# Access Compliance Report

## Public Rights-of-Way

Intersection ID: 29978	Main Street: ALBANS_LN	Cross Street: BARVAS_ST	Location: SW
ADA ID: A37A057D752B	Ramp Type: PerpDiag	Initial Pass/Fail: Fail	Overall Compliance: No
Severity Score: 58.75			
Codes/Mitigation Info/Possible Solution		Field Measurements/Component Compliance

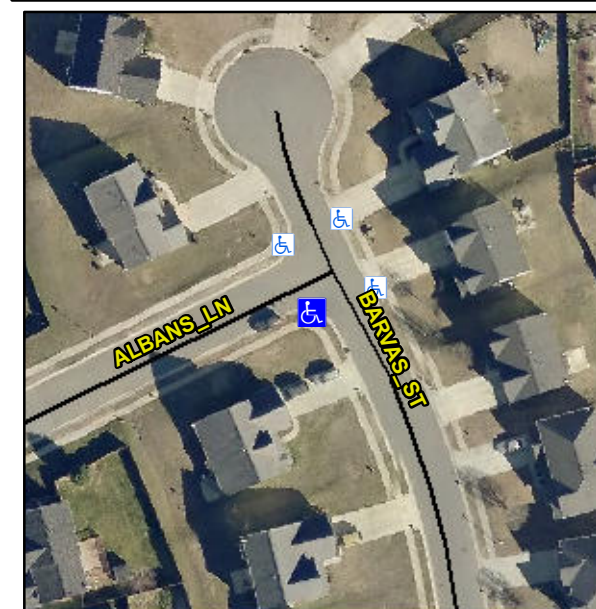
**Remove & Replace Curb Ramp With Two New Directional Ramps or Equivalent.**

**R304.5.1, R304.2.2, R304.5.3**

Compliance	Description	Data	Compliance	Description	Data
N/A	Ramp Length (in)	48.0	No	Ramp Slope (%)	13.2
No	Ramp Width (in)	47.0	No	Ramp XSlope (%)	9.7
N/A	Flare Type LT	N/A	N/A	Flare Type RT	N/A
N/A	Flare Slope LT (%)	N/A	N/A	Flare Slope RT (%)	N/A
N/A	Flare Traversable LT?	N/A	N/A	Flare Traversable RT?	N/A
N/A	Landing Length (in)	N/A	N/A	DWS Provided?	N/A
N/A	Landing Width (in)	N/A	N/A	DWS Contrast?	N/A
N/A	Landing Slope (%)	N/A	N/A	DWS Length (in)	N/A
N/A	Landing X Slope (%)	N/A	N/A	DWS Full Width?	N/A
N/A	Landing Curb? (Y/N)	N/A	N/A	DWS Offset (in)	N/A
N/A	Shared Landing?	N/A			
N/A	Gutter Ponding?	N/A	N/A	Gutter Slope (%)	N/A
N/A	Gutter Lip Ht (in)	N/A	N/A	Gutter X Slope (%)	N/A
N/A	Painted X Walk1?	No	N/A	Painted X Walk2?	No
	X Walk 1 Direction	To E		X Walk 2 Direction	To N
N/A	X Walk 1 Width (in)	N/A	N/A	X Walk 2 Width (in)	N/A
	X Walk 1 Slope (%)	1.3		X Walk 2 Slope (%)	1.8
	X Walk 1 X Slope (%)	3.2		X Walk 2 X Slope (%)	6.2
